RECREATIONAL VEHICLE CUSTOMER SATISFACTION

April 7, 2022

Customer Satisfaction Campaign: 22-425

CUSTOMER SATISFACTION CAMPAIGN

Fig. 1

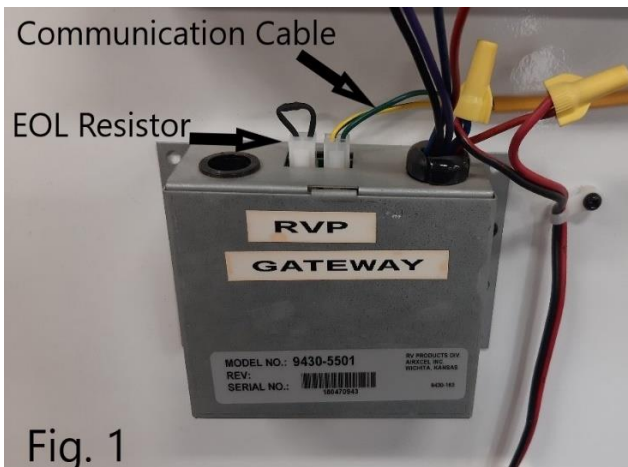
Figure 1-Shows a Gateway, the communication cable from In-Command system and the EOL resistor as it should be for proper operation.

4. Note: When a 2nd A/C is installed later, unplug the EOL resistor from the 1st Roof A/C Gateway, reinstall the 2nd A/C communication cable. Install the Pre-wired Communication cable and the EOL resistor into the 2nd A/C Gateway as seen in Figure 1.

Fig. 2

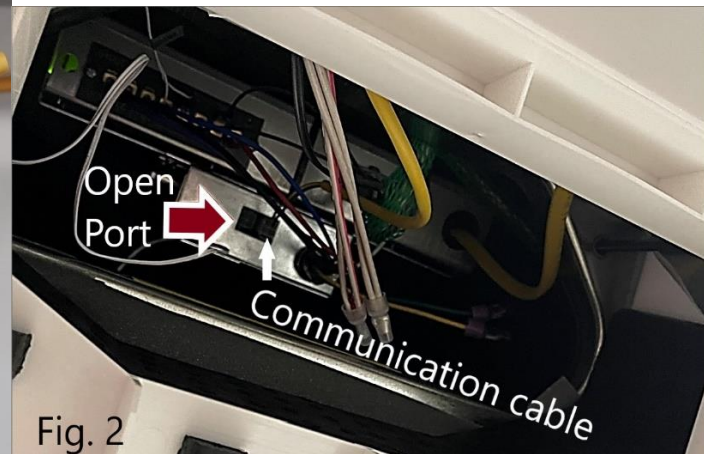
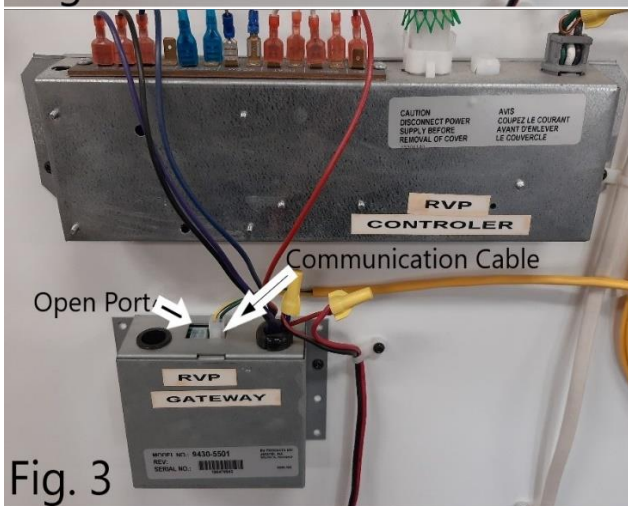
1. System with one Roof A/C. Turn off the A/C, remove the return air grill, and locate the Gateway (See Figure 2). If there is an open port as seen in Figure 2 & 3, corrective action is needed. Upon completion, the wiring should be as seen in Figure 1.

Fig. 4

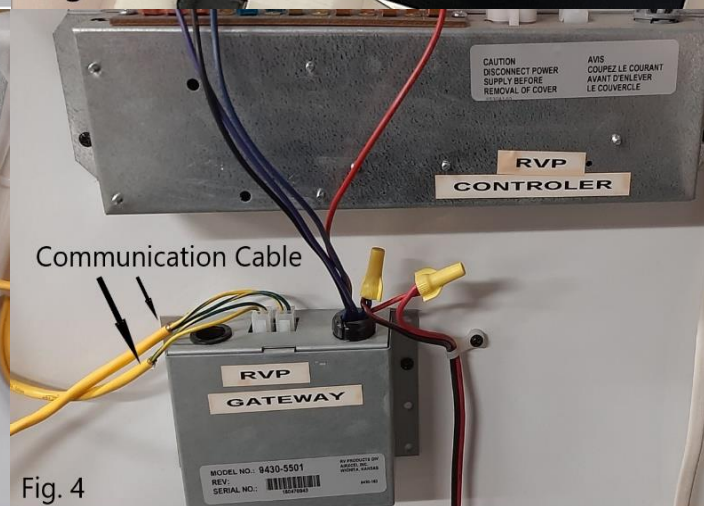
2. System with two Roof A/C's. Turn off the A/C's, remove the return air grill, and locate the Gateway's. The EOL will need to be installed on the 2nd A/C's Gateway. The first A/C Gateway (typically the middle of the unit) will have two communication cables plugged in (See Figure 4). One cable from In-Command to the 1st A/C, one cable from the 1st A/C to the 2nd A/C. The second A/C Gateway should look like Figure 1, if not, take corrective action.

3. System with one Roof A/C and Pre-Wired for 2nd A/C. If Pre-Wired for 2nd A/C, the 1st A/C Gateway may have two communication cables plugged in, See figure 4. One cable from In-Command to the 1st A/C, one cable from the 1st A/C to the 2nd A/C. The 2nd A/C communication cable will need to be unplugged and the EOL Resistor will need to be plugged in to that port. See Figure 1. The 2nd communication cable can be left protected and unplugged. To determine which communication cable is "live" unplug one cable at a time and operate the A/C functions at the In-Command panel.
